PROJECT NO. 55718

RELIABILITY PLAN FOR THE	§	PUBLIC UTILITY COMMISSION
PERMIAN BASIN UNDER PURA §	§	OF
39,167	§	TEXAS

TEXAS INDUSTRIAL ENERGY CONSUMERS' COMMENTS

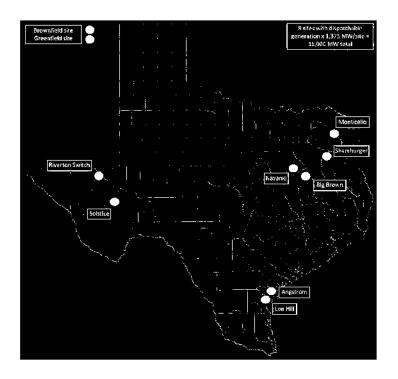
765-kV facilities in central and east Texas is required for the 765-kV facilities to provide a net benefit, even if the load growth is almost 16 GW less than anticipated. These facilities are shown below in pink.

ERCOT's analysis demonstrates that 765-kV facilities cost around \$2 billion more than the 345-kV facilities under the expected load growth and around \$3 billion more if load growth is roughly 16 GW lower than expected. As the load forecast decreases, it's likely that the cost differential between 765-kV and 345-kV would continue to increase because under any load scenario, there would still need to be a backbone of 765-kV facilities but you could incrementally eliminate or delay 345-kV facilities to match the updated needs.
